Remarks

Reference is made to the marked-up drawings. Entry of the replacement sheet drawings is respectfully requested.

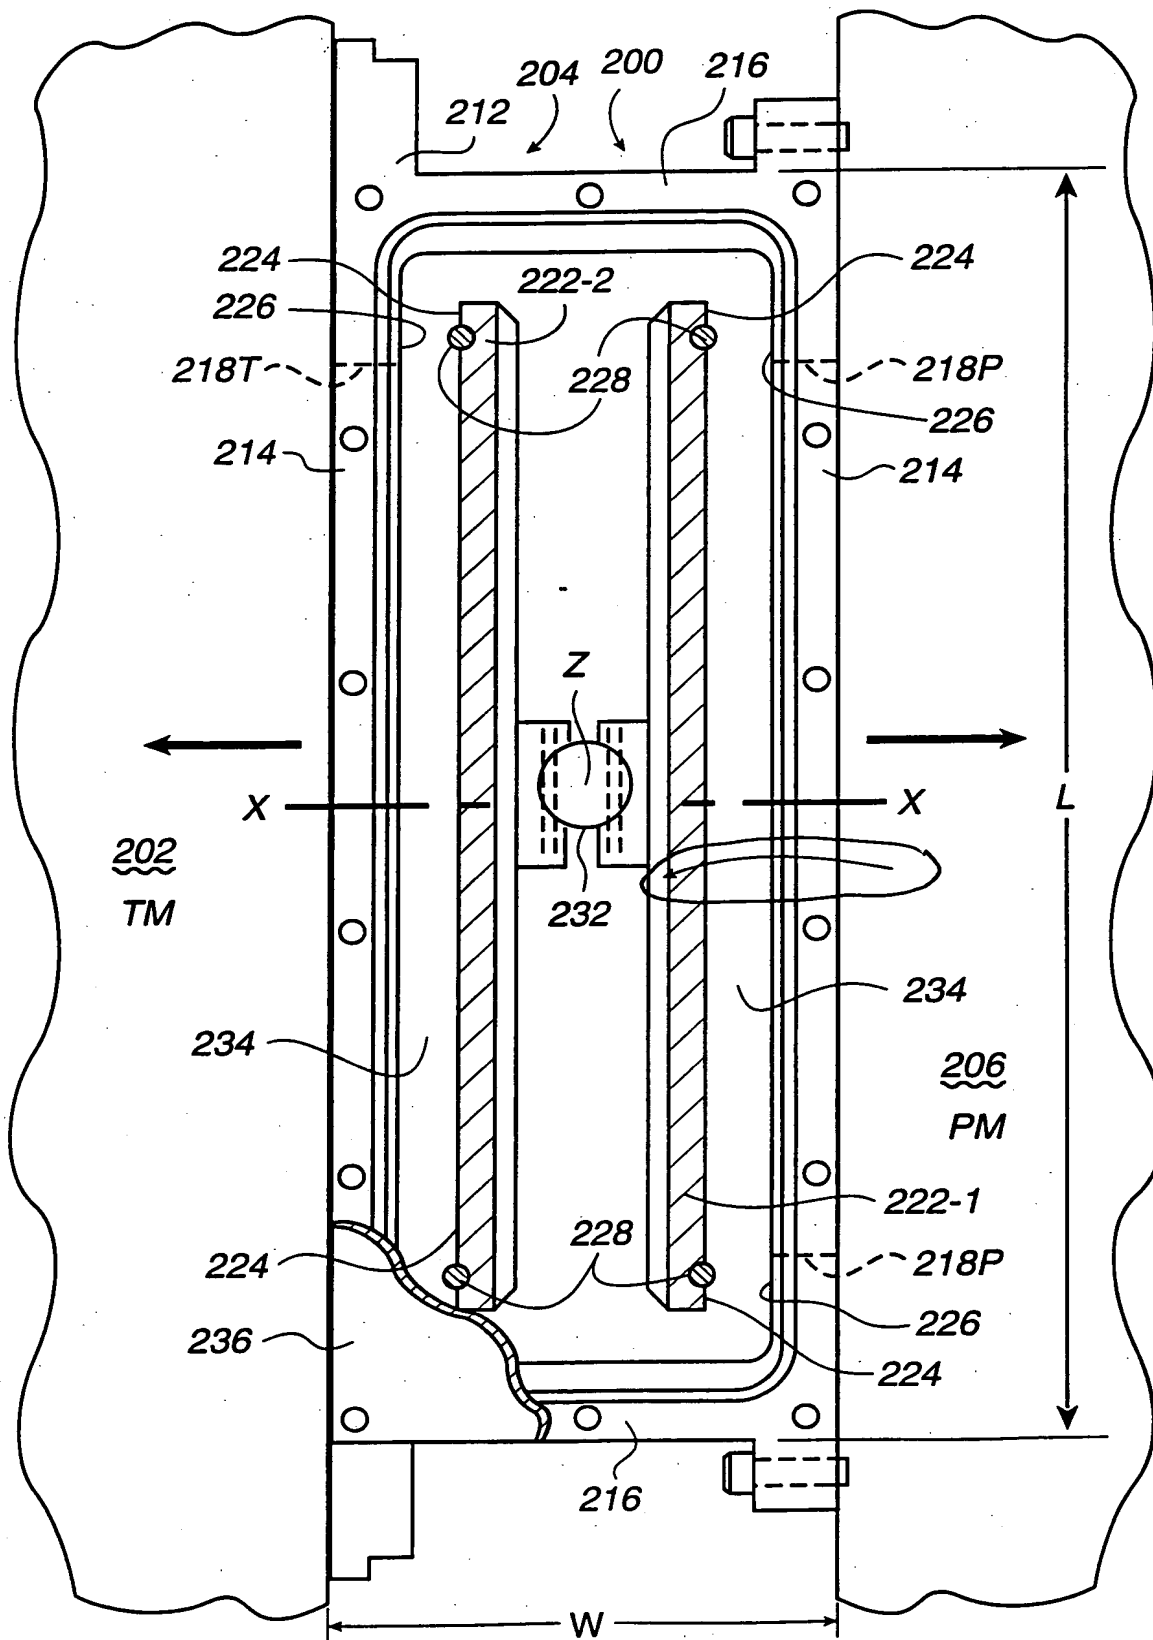
Fig. 3 identifies (by an oval) a lead line that has been removed because no reference number was denoted by the lead line.

Fig. 4A

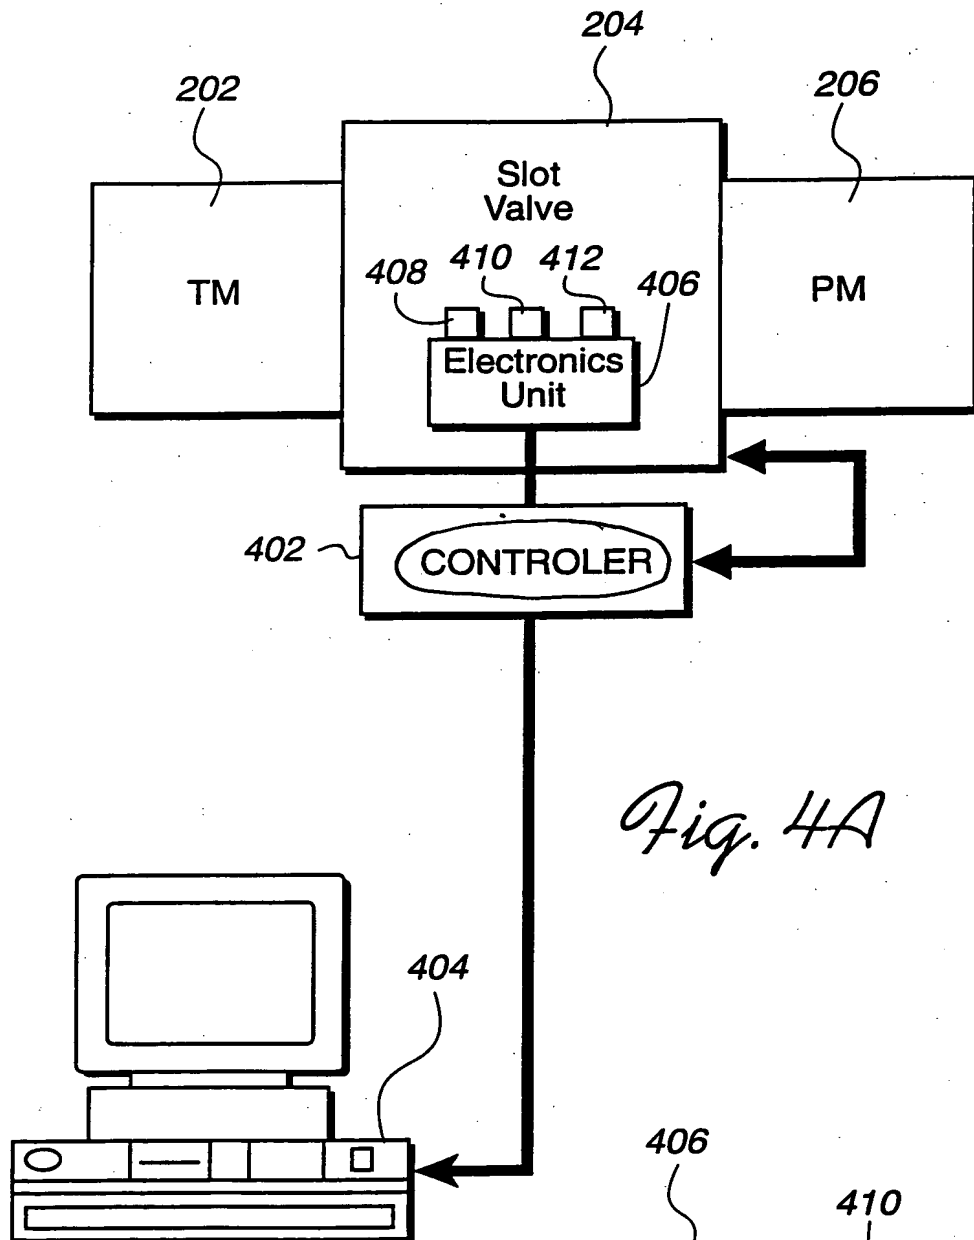
In Figure 4A, an oval identifies the word "CONTROLLER" the spelling of which has been corrected.

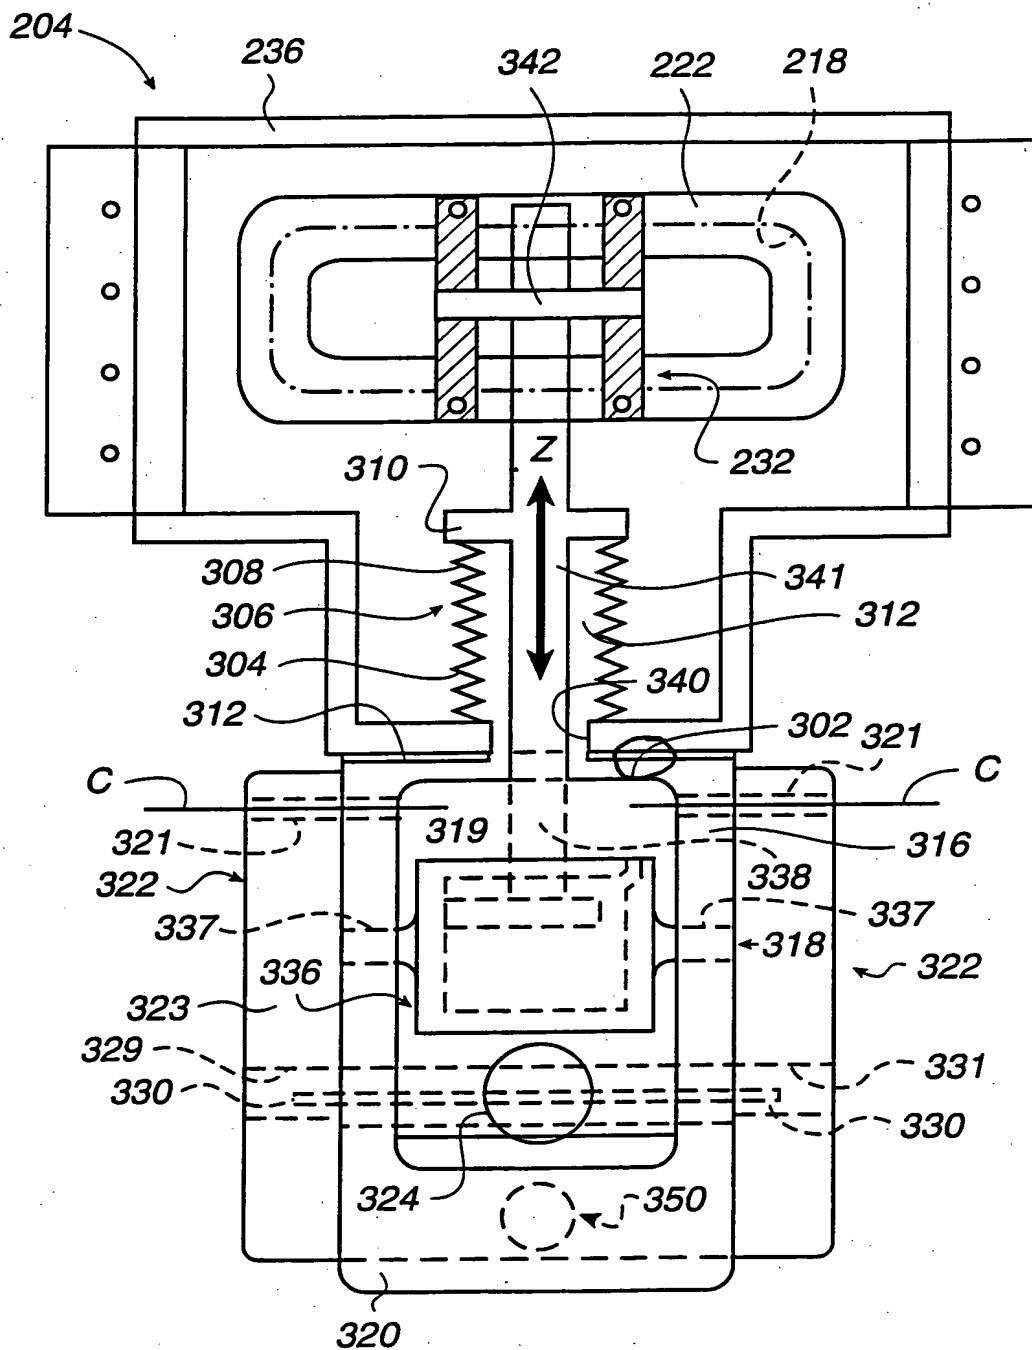
In Figure 5, a circle identifies a portion of a lead line that has been deleted, so that Figure 5 conforms to Figure 6A.

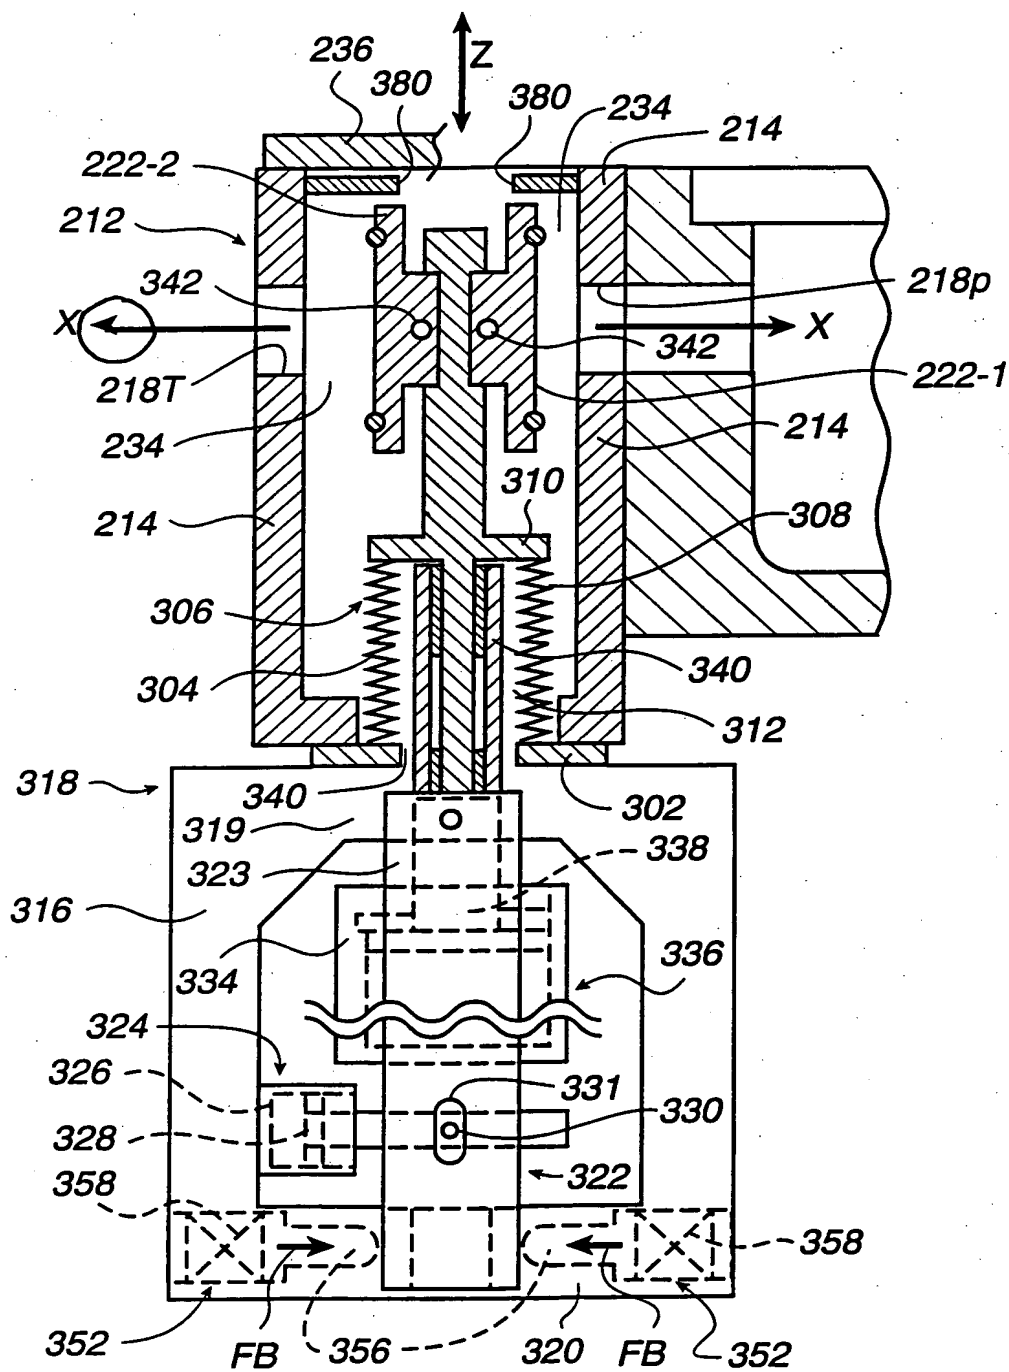
In Figures 6A and 6C, a circle in each Figure identifies an arrowhead that has been corrected.

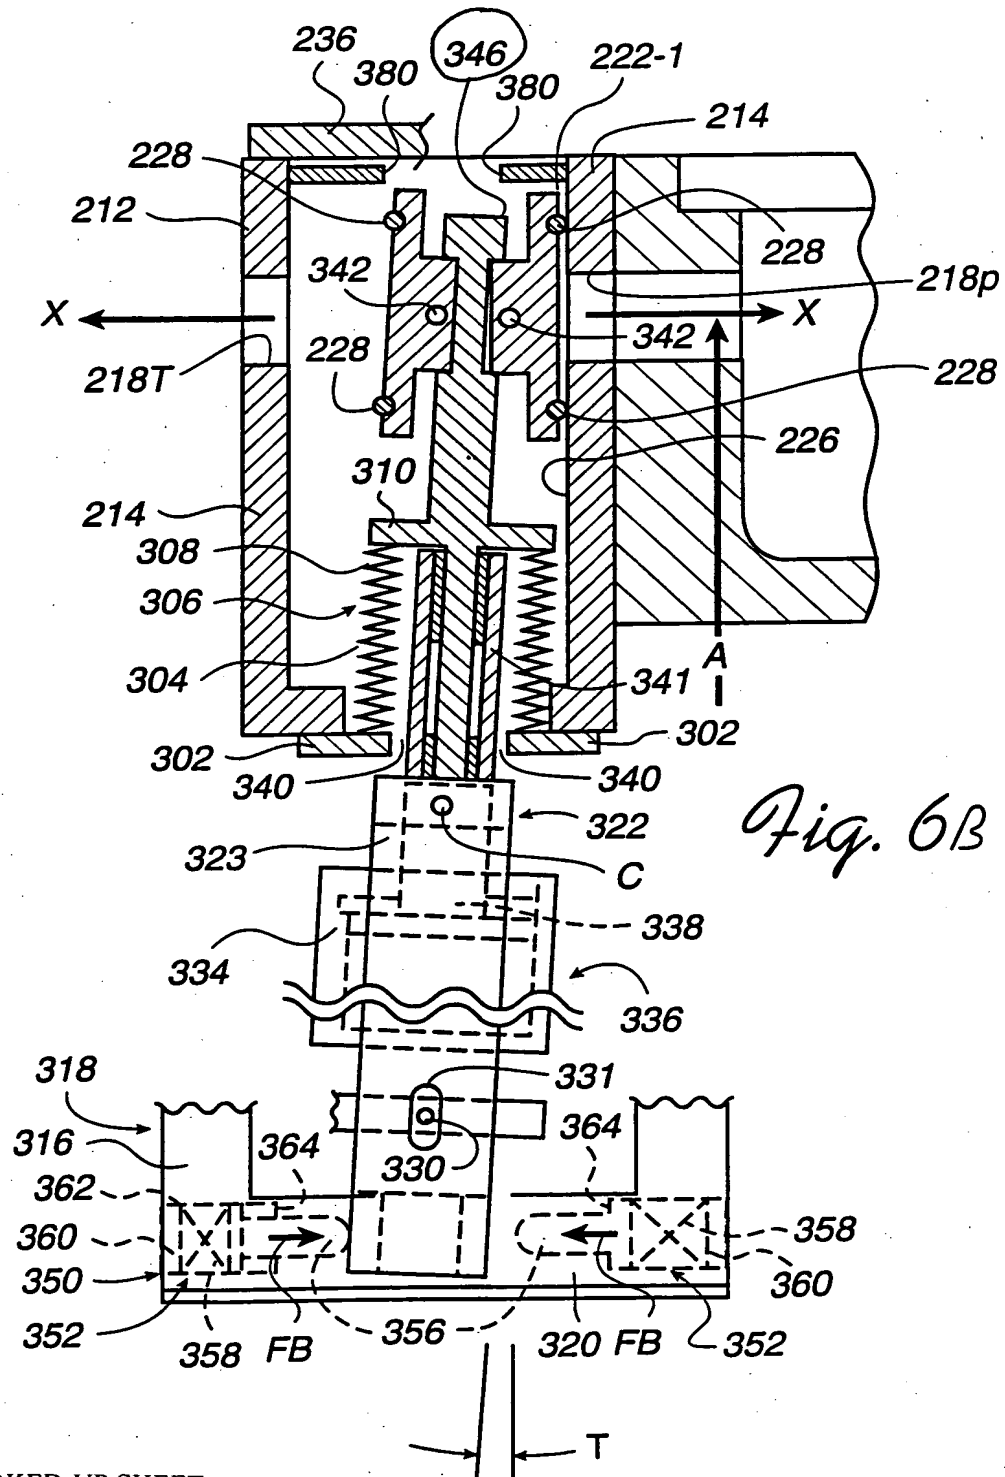
In Figure 6B, a circle identifies the reference number 346 (and lead line) which have been removed because no such number is referenced in the description.
